Wellington International Airport
Visual Effects of Designation Outcomes

Response to Request for Further Information

Prepared for Wellington International Airport Ltd

October 2020

VS10: Stewart Duff Drive

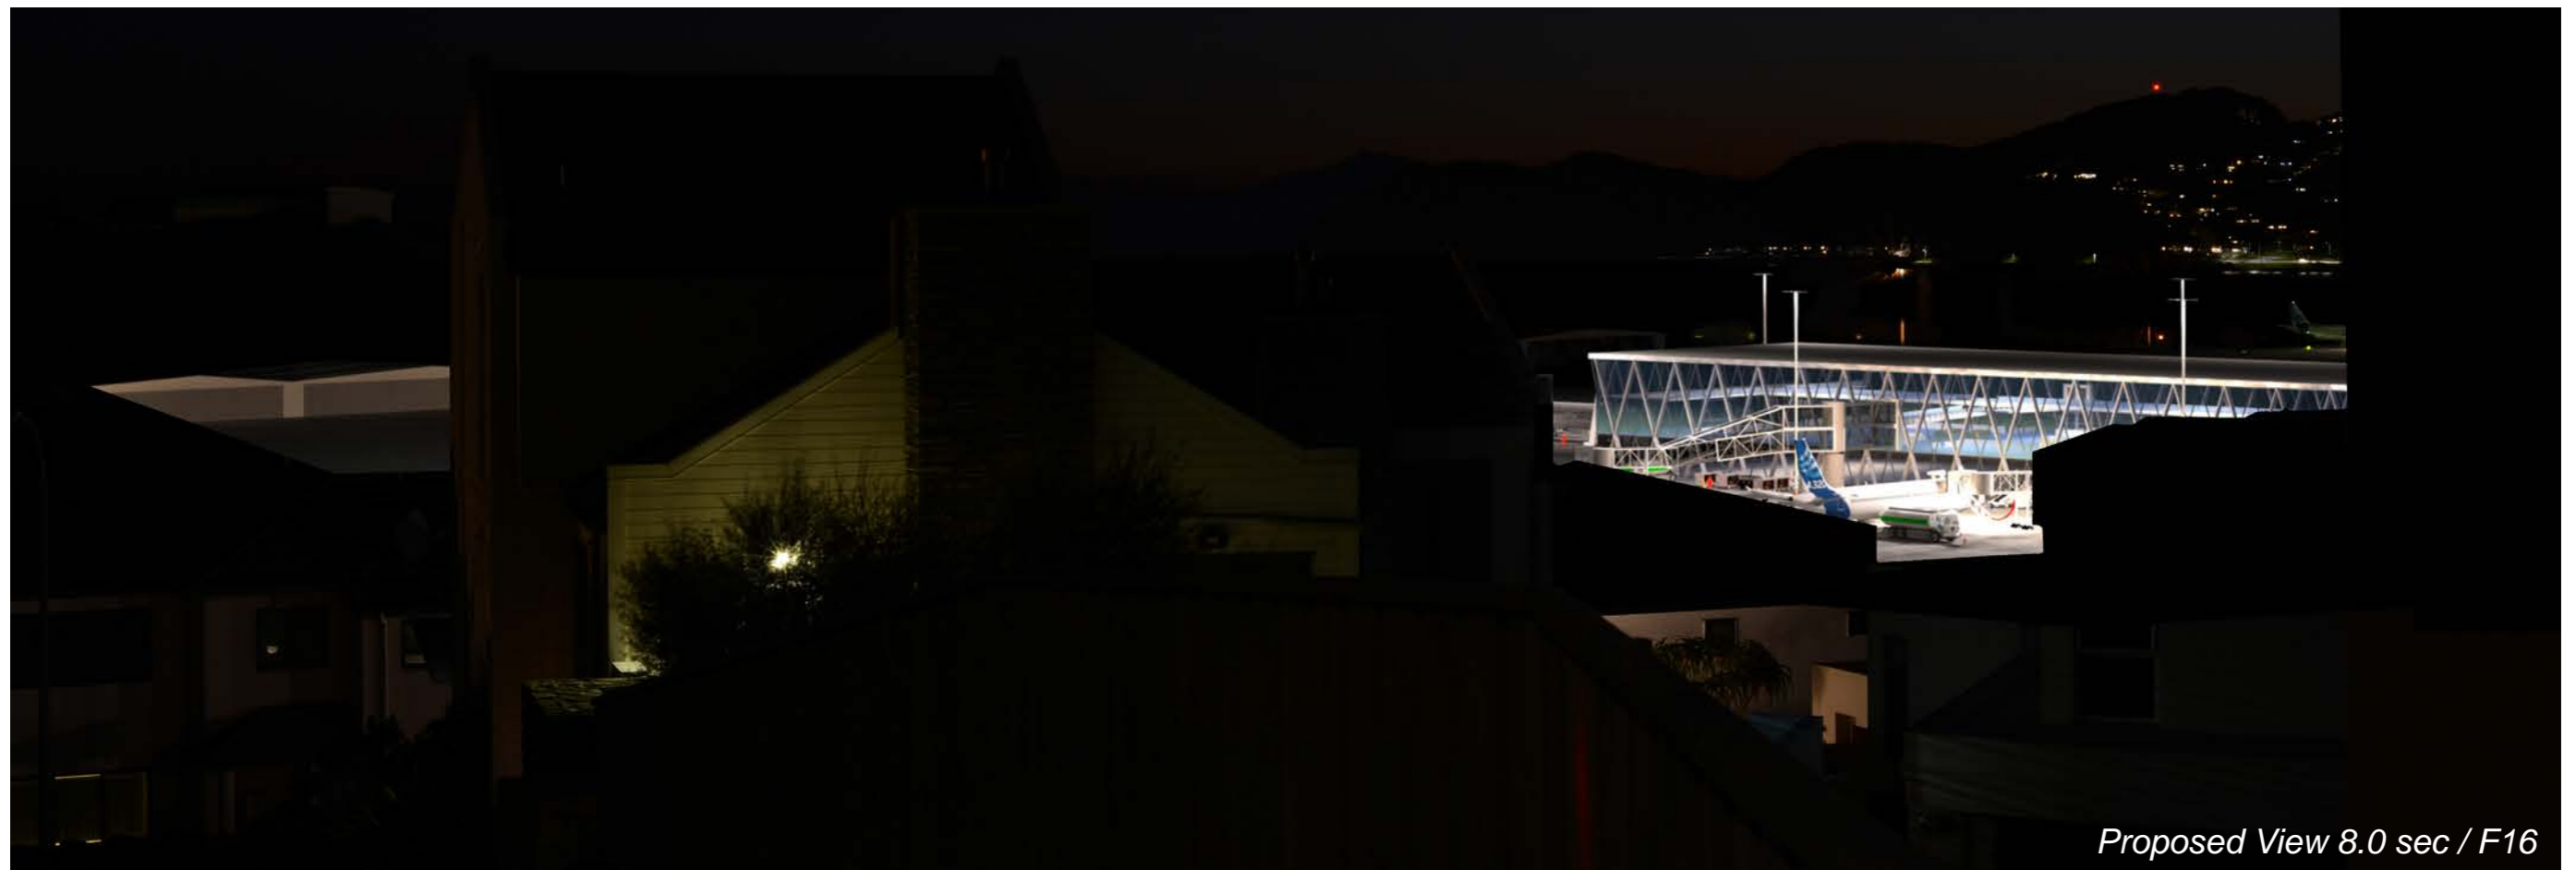
5. From Stewart Duff Drive

5.1 As requested a simulation has been prepared from Stewart Duff Drive (Viewpoint 9). While the request suggested a viewpoint approximately 190m from the Moa Point Road, a location some 150m from the intersection was selected as being more appropriate and representative. Simulation 9A shows the existing and proposed views based on a 90° field of view, with simulation 9B showing the same view as a single frame 40° view.

5.2 As is evident, the simulations from this location expose more of the airport activities and in particular the apron area. While the removal of the existing hillock makes the airport activities more apparent, in the context of the area and view overall, the view (while different) is likely to be seen as an enhancement, with more open and expansive views over the airport and the background Strathmore Heights area.

Existing View 8.0 sec / F16

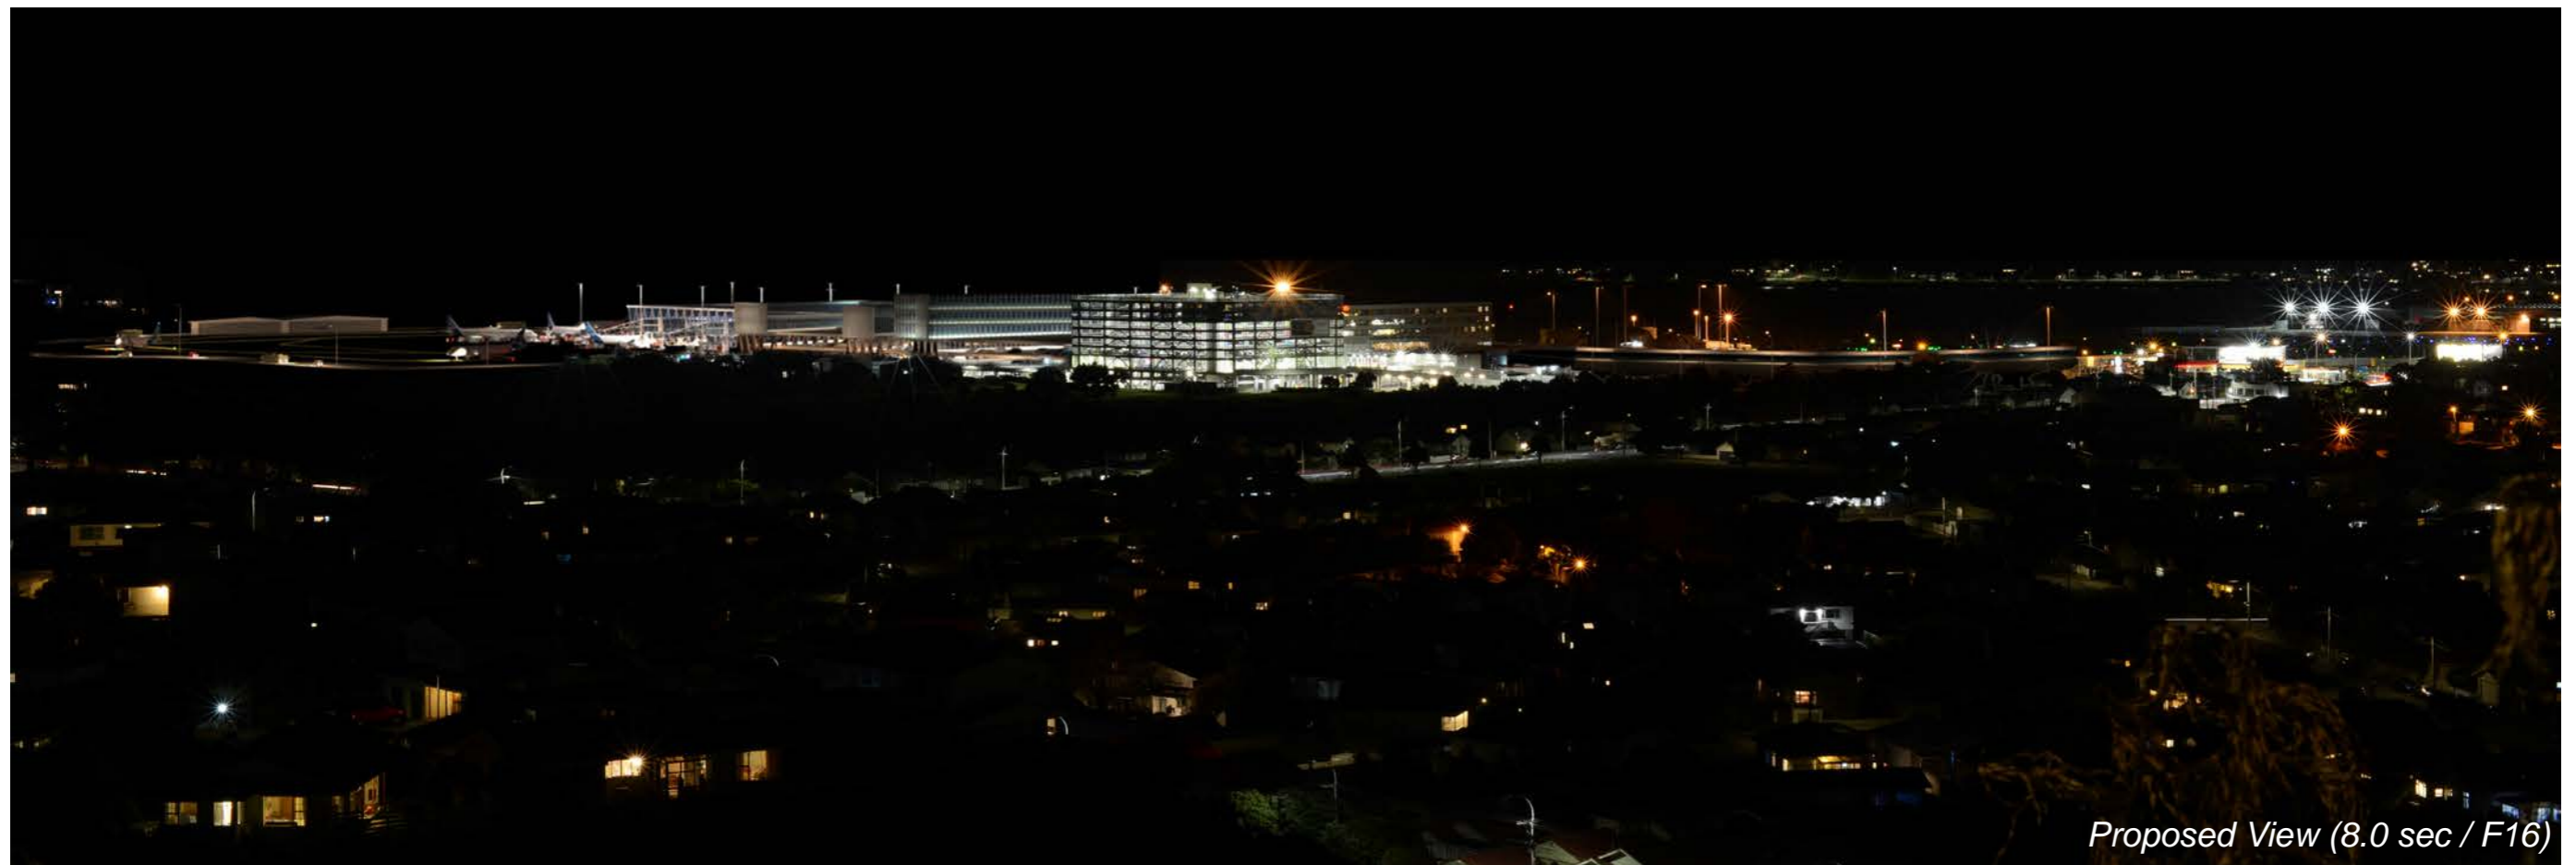
6. Night Views

6.3 From the Bunker Way viewpoint which is a combination of two previous viewpoints namely, VP2B and 2C, a single frame 40° horizontal view has been produced. While the extent of this single frame view cuts off part of the outer edges of the view, it effectively covers the designation modifications that would be most visible. In the night simulation the terminal building extension is clearly visible, whereas the apron lighting tends to be less visible due in part to nature of the LED downlights. Notwithstanding the visibility of the terminal building extension from this viewpoint, the use of a more opaque or tinted glass on the façade facing the Strathmore residential area could likely potentially significantly reduce visual effects at night.

6.4 As noted in paragraph 8.3 of the original assessment, from the Bunker Way area in general, *“there will be no screening or blocking of views, particularly those more expansive views extending beyond the immediate foreground. Visual effects from this area are likely to be high to very high.”* While the content and detail of the expansive views will largely be less apparent at night, the suggested mitigation in the form of more opaque or tinted glass on the eastern façade of the building would potentially reduce the visual impact of the structure at night.
